**Board of Property Maintenance Appeals
Board Meeting**

301 N. MULBERRY STREET

Communication: Notice of Appeal (301 N. Mulberry Street)

Re: 301 North Mulberry Street Structural Condition Assessment
301 North Mulberry Street
Mount Vernon, Ohio, 43050

Photo 18: Vertical crack in smokestack brick (arrow).

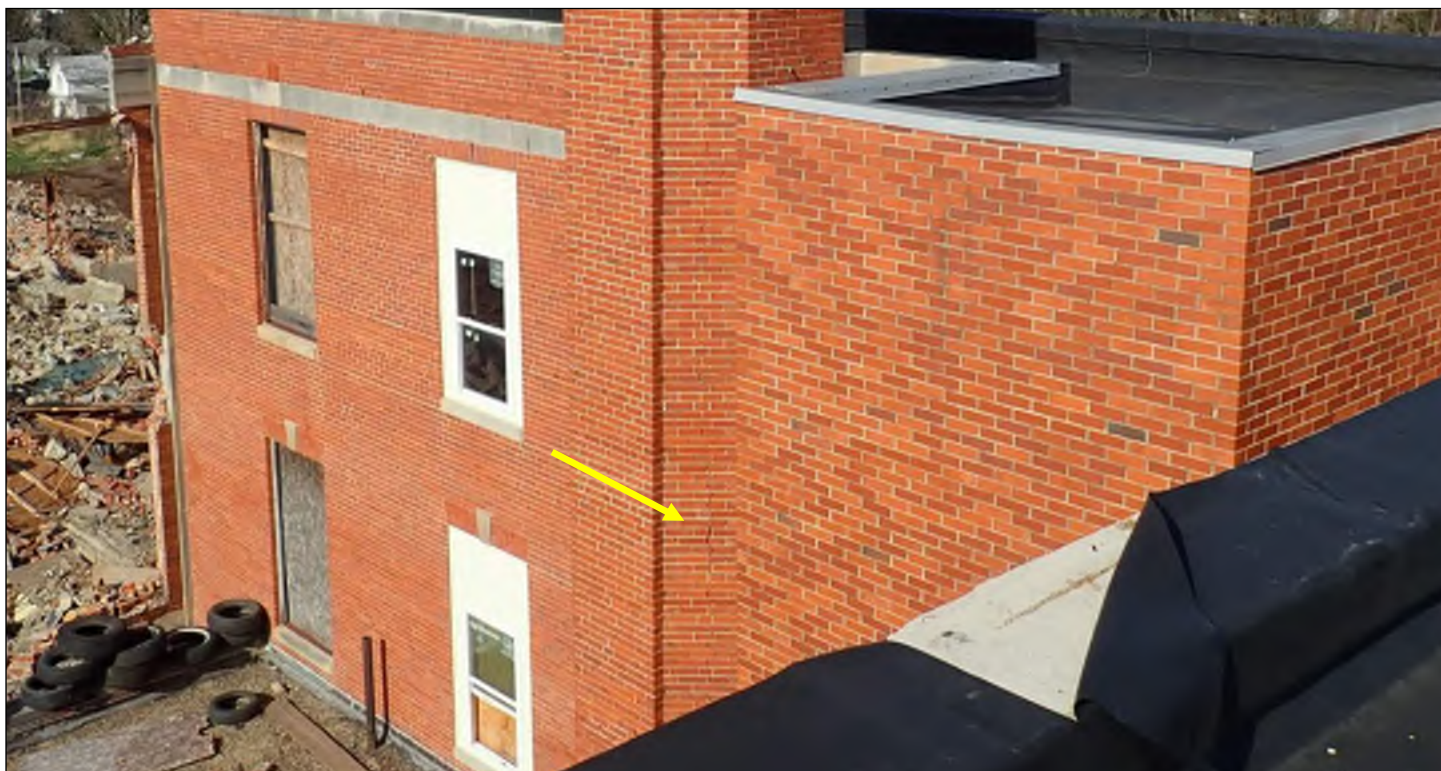
- 2.2.5 Deterioration of mortar joints and cracks through brick masonry were observed on the smoke stack located at the west (rear) of the building (Photos 17 through 19). Mortar was almost entirely missing from some joints (Photos 20 and 21).

- 3.2.1 Cracks and mortar joint deterioration on the smokestack were due to water infiltration and freeze/thaw cycles. Loose bricks are a potential safety hazard, but the smokestack did not appear to be in danger of imminent collapse. Recommended repairs would be removing and resetting loose bricks and tuck pointing cracked mortar.

Photo 25: Horizontal and "stair-step" cracking along mortar joints near northeast corner.

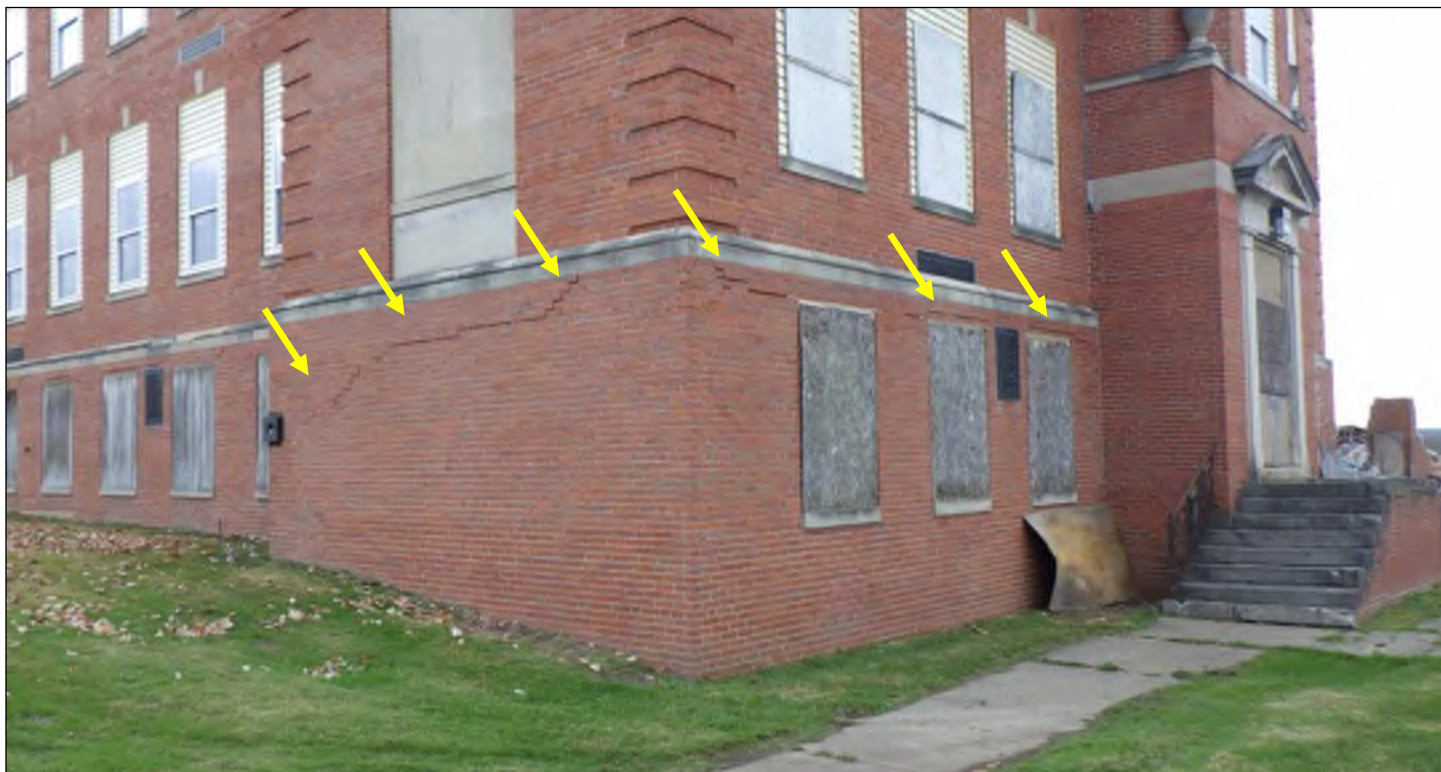
- 2.2.7 Exteriors of the brick masonry bearing walls appeared in overall fair to good condition. Horizontal and “stair-step” cracking along mortar joints in the masonry was observed near building corners and some openings (Photos 25 and 26). Vertical cracks through brick masonry were observed near the base of the west wall near locations where the wall jogs in plan (Photos 27 through 29). Most cracks were hairline and extended through only a few courses of brick, with the exception of a larger crack at the southernmost jog that measured approximately 1/8 inch-wide and approximately 3 feet long.

- 3.2.4 Stair-step cracks in the masonry bearing walls are common for masonry structures and suggest some differential settlement of the foundation, or differential movements between girder beams and their supporting columns have occurred. The amount of shifting/movement appeared small and has not affected the ability of the walls to support the structure. Recommended repairs would be tuck-pointing where cracks have occurred.

Photo 42: Close-up view of construction anomalies (arrows).

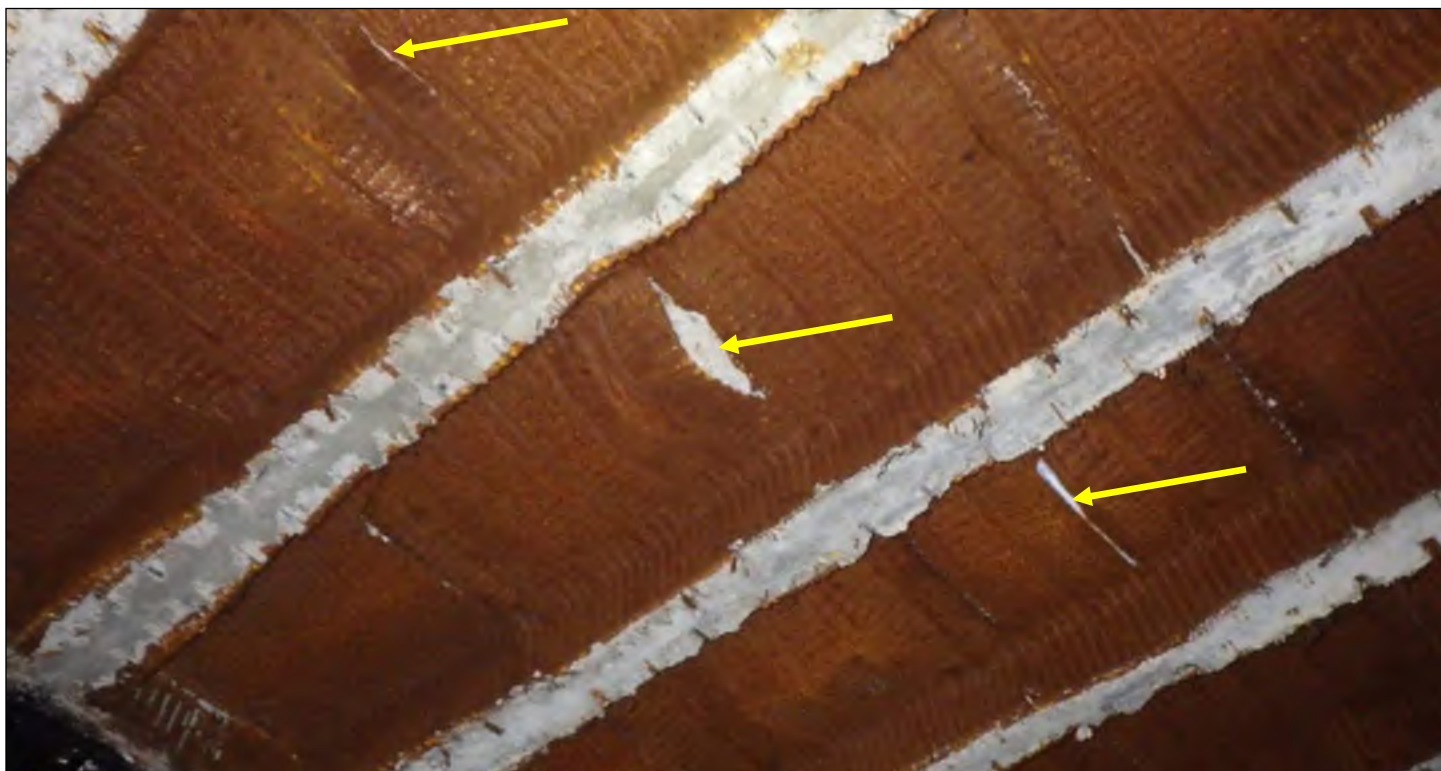
- 2.3.4 A construction anomaly was observed at several locations scattered throughout the building, where steel tile formwork had separated at lapped edges and allowed wet concrete to ooze through during construction (Photos 40 through 42).

- 3.3.3 The construction anomaly noted in Observation 2.3.4 does not adversely affect the strength of the floor and roof slabs.
- 3.3.4 Exposed longitudinal steel reinforcing bars (rebar) at the undersides of joists and lintels was due to poured concrete not fully consolidating during construction. The load-carrying capability of structural members are locally compromised where bars are exposed, as the reinforcement must be bonded to and surrounded by concrete in order for them to perform as intended. Overall, exposed rebar was observed at scattered locations throughout the building, occurring at a small minority of joists. However, most joists retained plaster finish that would have obscured any signs of poor consolidation or exposed rebar, and it is anticipated these conditions may be present at some additional locations. The floor and roof slabs did not exhibit signs of distress, suggesting that hidden exposed rebar is not a widespread issue, and that the structural integrity of the slabs is adequate for the building’s current unfinished and unoccupied condition.

Photo 43: Plaster at the underside of concrete joists. Note rusty ribbed lath (arrows).

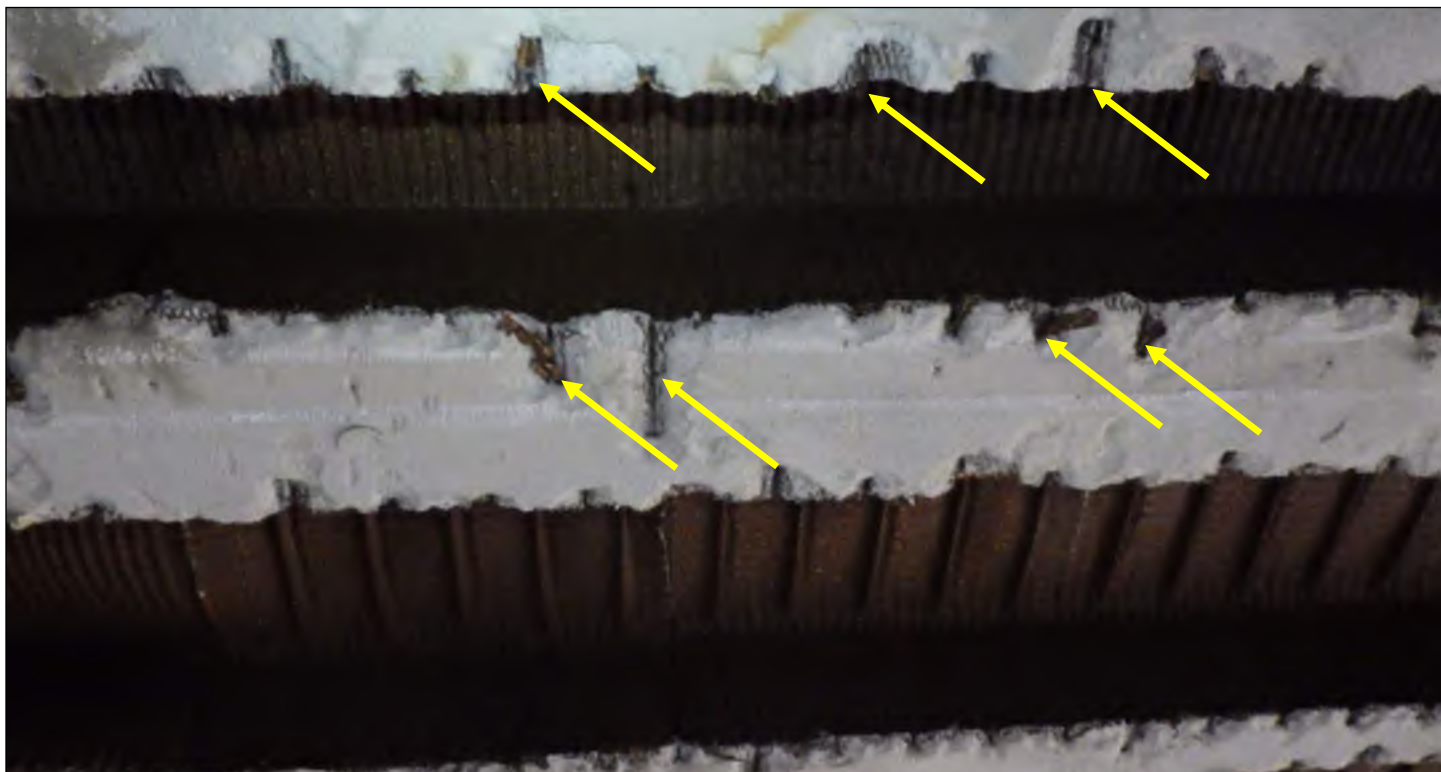
- 2.3.5 Plaster ceiling finish on ribbed metal lathe had been previously removed from between joists in most locations. Plaster and ribbed lathe remained in place along the bottom of most joists, with corrosion apparent on all exposed lathe (Photo 43).

Photo 48: Exposed corroded internal steel reinforcement at joists (arrows).

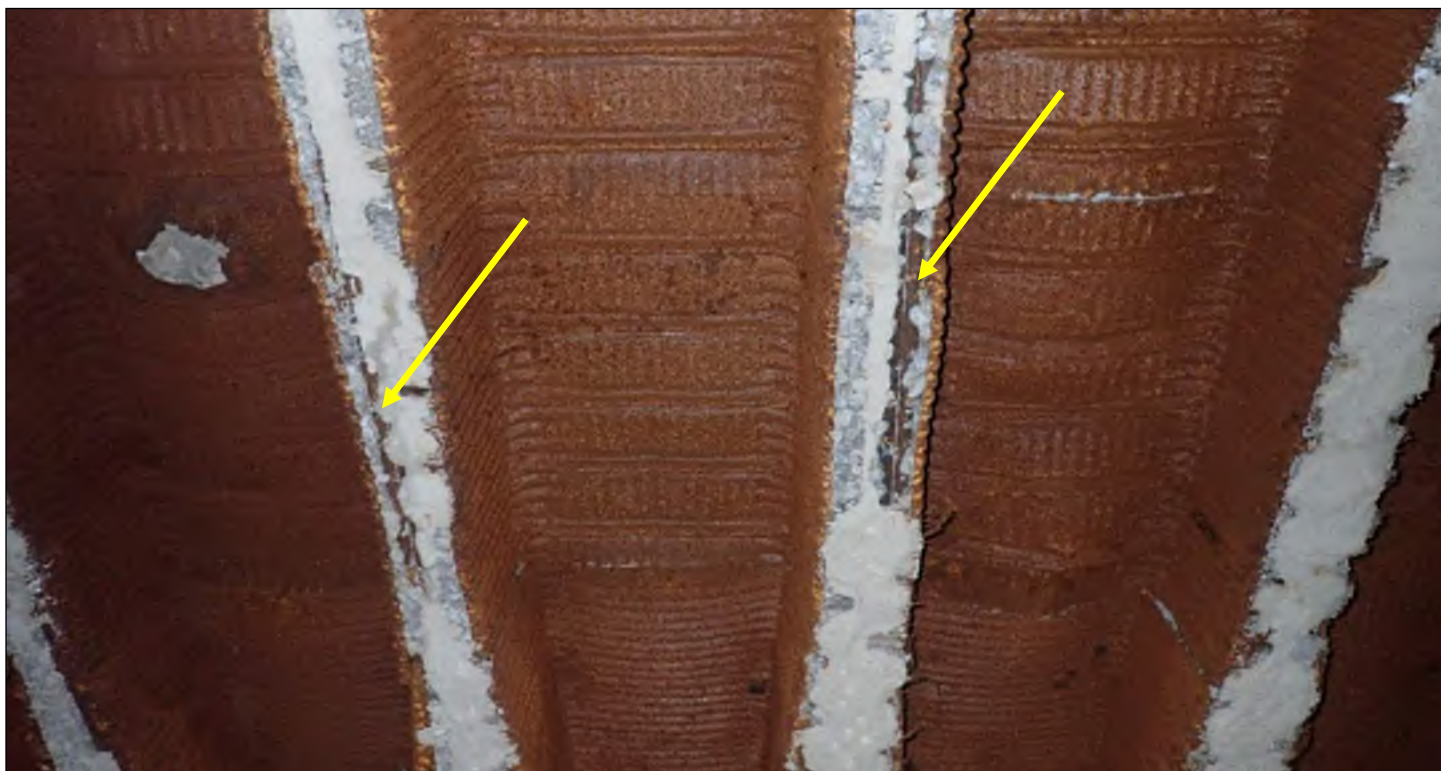
- 2.3.7 A chunk of concrete was observed to be missing from the corner of one roof beam (Photo 45).
- 2.3.8 Exposed, corroded longitudinal steel reinforcing bars were observed at the underside of some reinforced concrete joists, and lintels, characteristic of poor consolidation of the concrete (Photos 46 through 50).

Photo 51: Spalled concrete and exposed corroded internal steel reinforcement at beam (arrow).

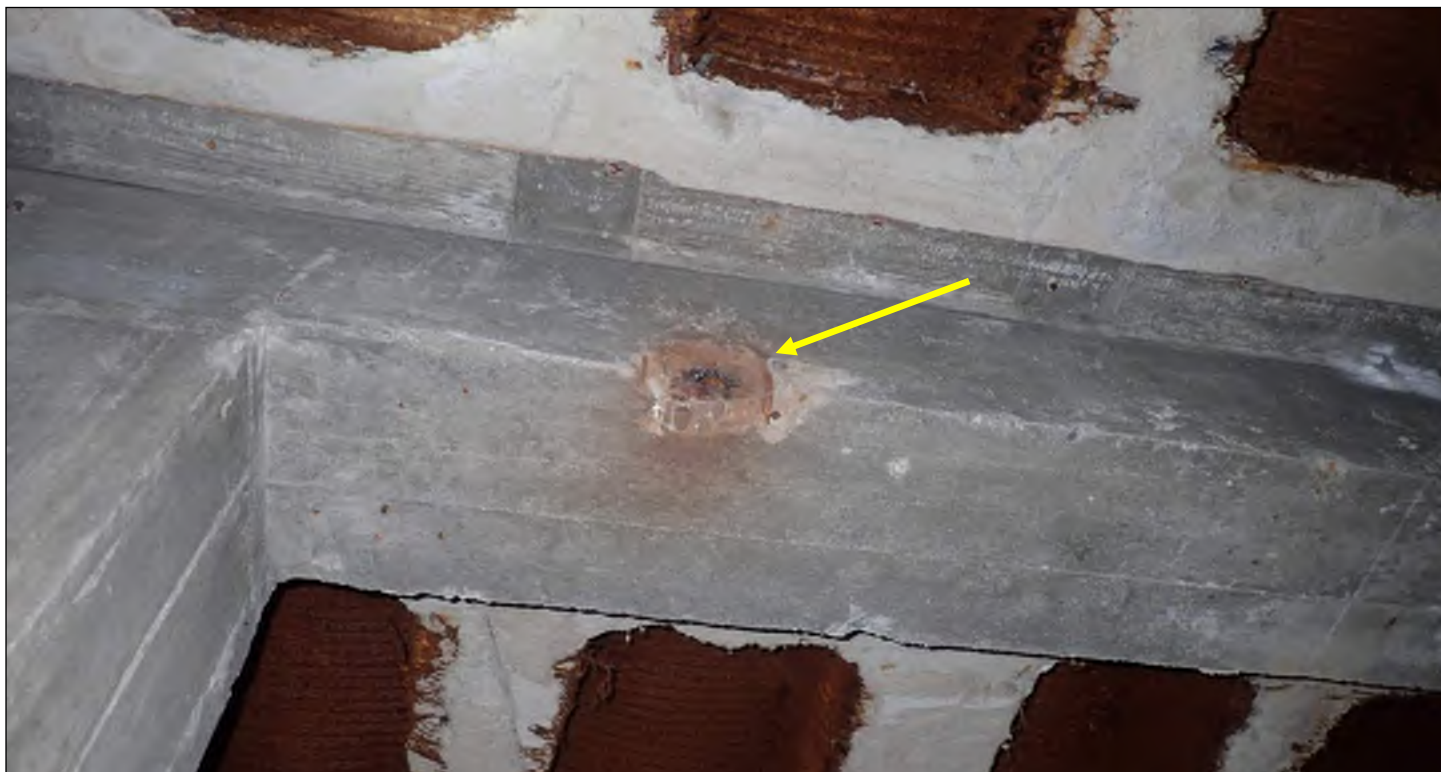
- 2.3.9 One spall characteristic of corroded steel reinforcement was observed on a concrete beam (Photo 51).
- 2.3.10 Several piping penetrations were observed in one double-width reinforced concrete joist supporting the third floor (Photo 52).

- 3.3.5 The spall on a concrete beam noted in Observation 2.3.9 occurred due to corrosion (rusting) of the internal steel reinforcing bars (rebar). When steel rusts, the corrosion products expand to as

Photo 70: Efflorescence on below-grade boiler room walls (arrows).

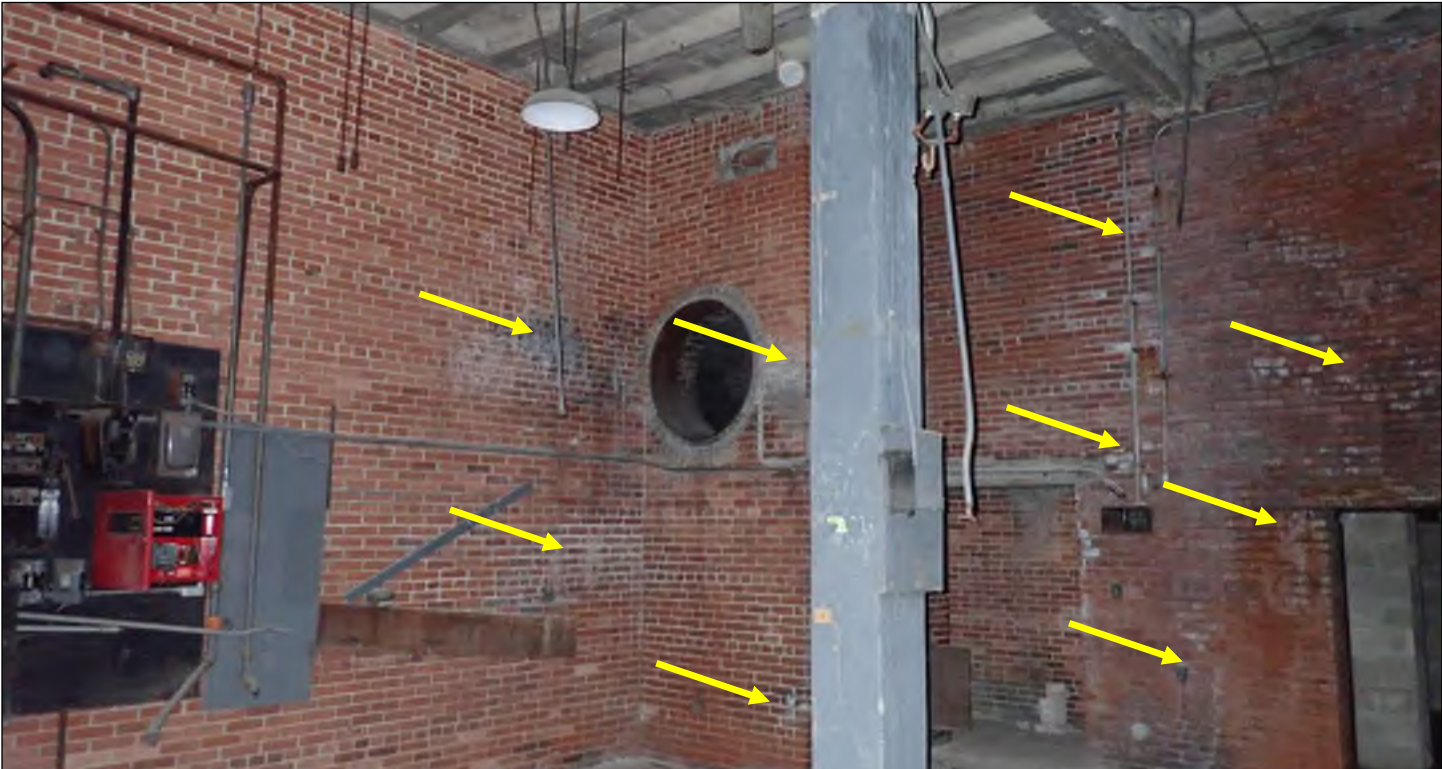
- 2.6.1 Soffits at the underside of the boiler room roof slab did not have metal tile formwork, unlike roof and floor slabs throughout the rest of the building (Photo 67).
- 2.6.2 Cracks and water staining characteristic of long-term water infiltration were observed on the roof slab (Photos 68 and 69). White powdery deposits (efflorescence) characteristic of prolonged water infiltration were observed on the below-grade boiler room walls (Photo 70). Mineral deposits from dripping water were observed at the underside of the roof slab in the room adjacent to the boiler room (Photo 71).
- 2.6.3 An active water leak was observed at cracks on a below-grade boiler room wall (Photo 72).

- 3.6.1 The underside of the boiler room roof slab appeared in overall fair condition, with signs of long-term water infiltration and associated cracking, staining, and moisture.
- 3.6.2 The active leak through the subgrade masonry wall and efflorescence on the boiler room walls indicate water infiltration has been an ongoing issue. Further evaluation would be necessary to determine the extent of necessary repairs to below-grade walls.
- 3.6.3 Based on the extensive signs of long-term water infiltration and deteriorated/cracked locations on the concrete roof slab, the boiler room roof is at or near the end of its expected service life, and should be replaced.
